## Planning Proposal for 3-7 East St & 2 Railway St, Lidcombe - Revised Development Concept Report.

Responsible Division: Environment & Infrastructure  
Officer: Group Manager - Planning  
File Number: HC-23-08-25

**Figure 2:** Original mixed use development concept prepared by Prescott Architects, dated July 2016

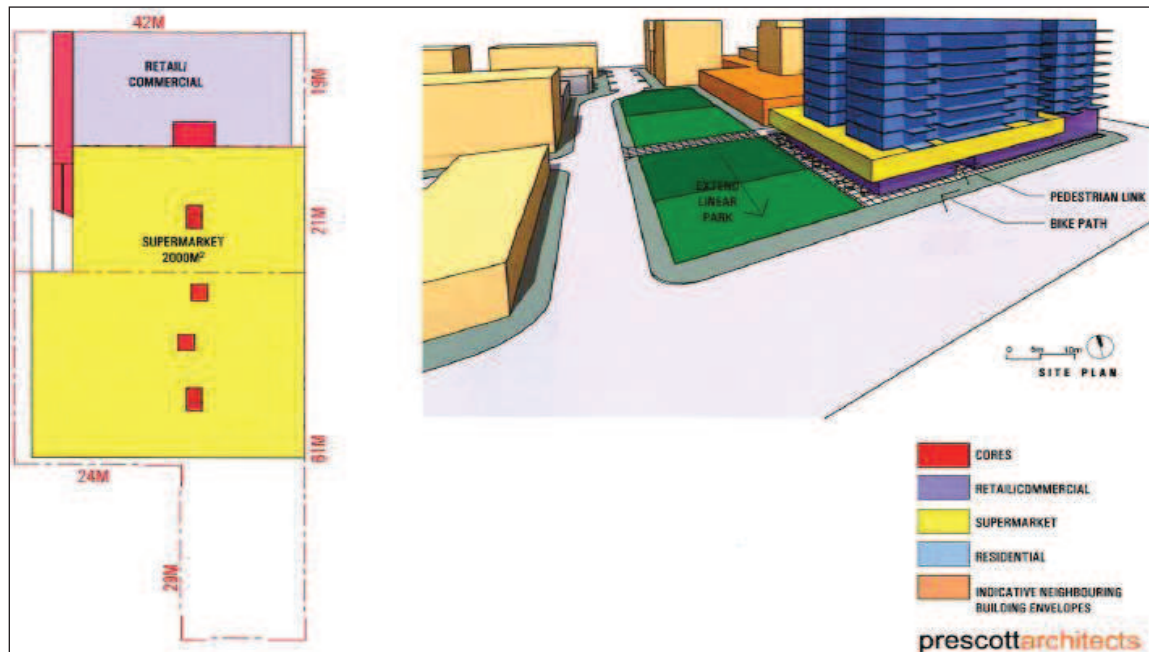
The original concept (**Figure 2**) sought to apply the same zoning and development standards of the Marsden Street Precinct (B4 Mixed Use, FSR 5:1 and 32m height), albeit without accurately testing the requested development standards. Council's building envelope testing for the site resolved that an appropriate FSR for the site, urban context and which would mitigate environmental impact would be 3.5:1. This is consistent with the findings of the recent Auburn and Lidcombe Centres Heights Review.

**Figure 3:** Revised development concept scheme drawings 05 - 06 perspectives prepared by Prescott Architects, dated January 2017

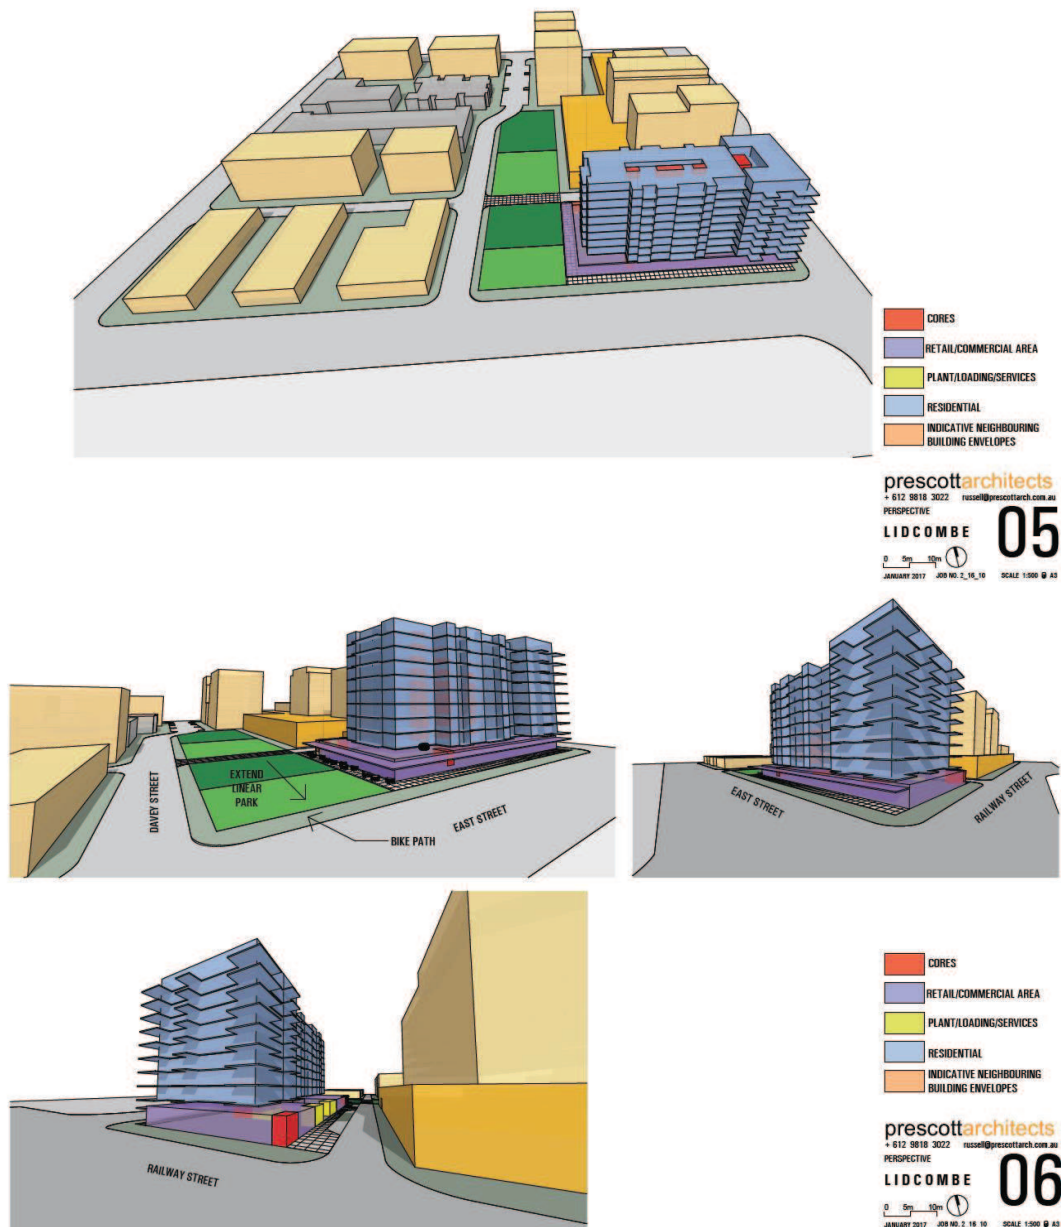
The revised concept (**Figure 3**) retains a 32m height (10 storeys comprised of nine (9) residential levels above one (1) ground level commercial podium with no specified uses) and FSR of 4:1 (GFA 12,035m<sup>2</sup>). The revised breakdown is FSR 3.5:1 (87%) residential (GFA 10,512m<sup>2</sup>) and FSR 0.5:1 (12.5%) commercial (GFA 1,523m<sup>2</sup>).

The proponent did not adequately demonstrate a planning argument (or provide envelope testing) for exceeding FSR 3.5:1 (10,512m<sup>2</sup>), other than to state that the revised concept provides more generous setbacks to the south (4m) and west (5.5m) to the park/Davey Street and Raphael Street respectively.

The resulting overshadowing from the revised concept has also not been justified. It is contended that there is existing cast shadow and that it is no longer council's position to specifically seek to retain solar access to the linear strip of proposed parkland extending from Mark Street to East Street connecting Remembrance Park to East Street (and including the southern portion of the subject site). This assertion is incorrect and council will seek to achieve reasonable solar access to any publicly accessible open space.

The revised request has not been suitably justified. Council maintains the position that the maximum FSR should result in a development smaller than the envelope; producing less bulk and greater articulation (varied setbacks and heights) and which mitigates environmental impact. Furthermore, that a more suitable FSR is 3.5:1 being 75% (7,885m<sup>2</sup>) residential and 25% (2,628m<sup>2</sup>) commercial.

Therefore, a design modification that demonstrates the proposed massing resulting from the floor space and height delivers a reduction in environmental impact (shadow for the land designated as a future park) should be provided. Consideration may be given to a revised concept which reduces shadow impact which may be achieved by a modified south western building envelope form and accompanied by building envelope testing by a qualified urban designer.

- Building envelope testing

- Design modifications that demonstrate that the proposed massing resulting from the floor space and height delivers a reduction in the existing shadow for the land designated as a future park
- An economic impact study to demonstrate the validity of the proposals appropriateness.
